URGENT Field Safety Notice

Allura Xper, Allura Centron, and Azurion systems
Potential loss of imaging functionality resulting from no or intermittent X-ray radiation initiation through the wired foot switch.

15-August-2023

Reference: 2023-IGT-BST-004: Allura Xper, Allura Centron, and Azurion Systems.

Figure 1: AD7XT and AD7XNT Patient Table

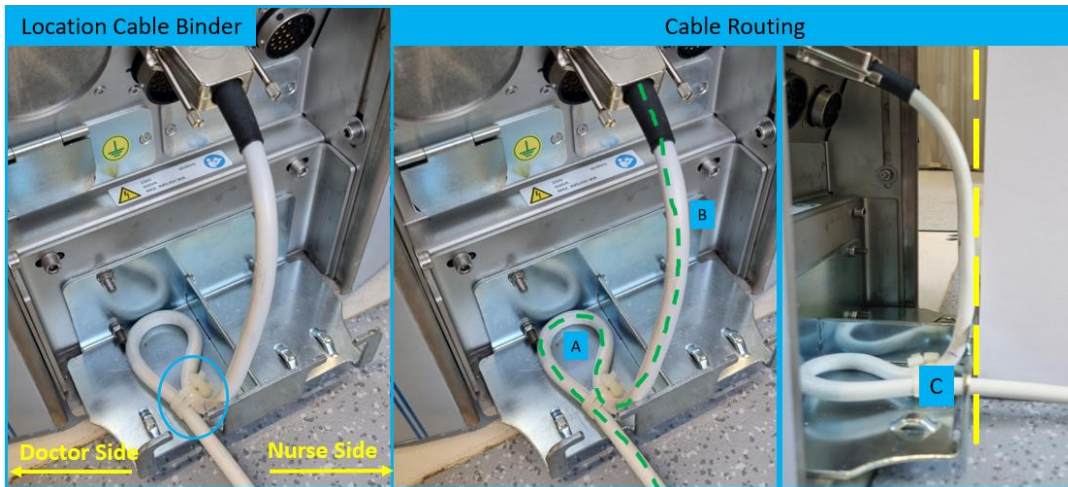
Check the strain relief and routing of the wired foot switch cable:

- Cable binder used for strain relief:
 - Type of cable binder(s)
 - Number of cable binder(s)
 - Position of cable binder(s)
- Cable routing (depending on picture indicated with "A" "B" "C")
- For AD7NT, there are 2 possibilities for strain relief:
 - Strain relief by means of bushing (Figure 4a)
 - Strain relief by cable binder (Figure 4b)
- For correct routing and strain relief, see Figures 1-6 below.

Number of cable binder(s): 2 (two)

Figure 7: Non-swivel table (AD7NT, AD7XT and AD7XNT)

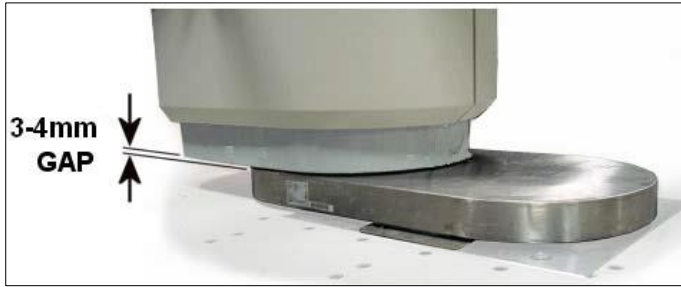
Check the clearance of the plinth cover:

- For a non-swivel table
 - Make sure that the clearance to the fluid protection plate is 3-4 mm
 - Refer to Figure 7
- For a swivel table
 - Make sure that the clearance to the swivel cover is 3-4 mm
 - Refer to Figure 8

If the gap between the plinth covers and the floor does not satisfy the above requirement, adjust the plinth cover according to the repair instructions.
